James Cerkanowicz <u>Stacy Radford; Bukowski, Rob</u> <u>Liz Burdick; Meredith Badalucca; Brad Pa</u> RE: <u>23SITE8</u> - 669 Rte 163, Oakdale, CT Monday, July 24, 2023 2:01:38 PM

Subject: 23SITE8 - 669 Rte 163, Oakdale, CT

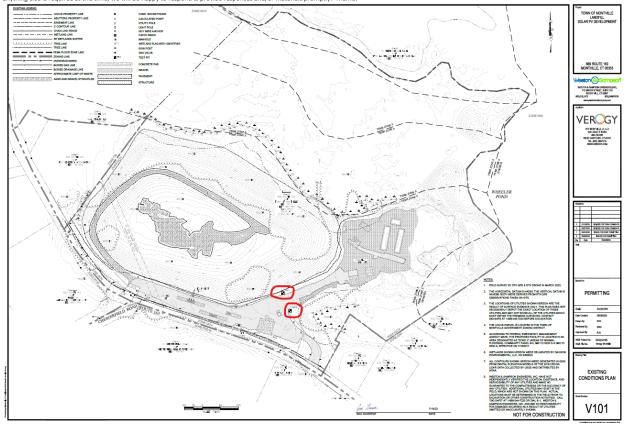
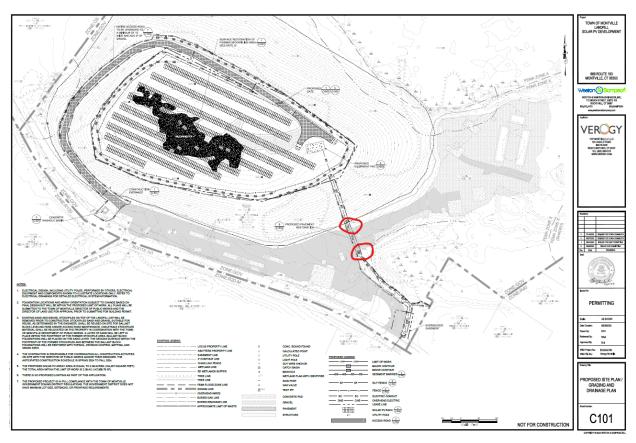
In response to the attached additional review comments from the Town Engineer dated 7/24/23, attached is a PDF of the test pit results in question. The results of the test pits, excavated to a depth of 2 feet, are a confirmation that this trench work will be occurring outside of the limits of the landfill cap. The locations for these test pits are indicated on both sheets V101 and C101 and on the screen captures below I have circled them in red.
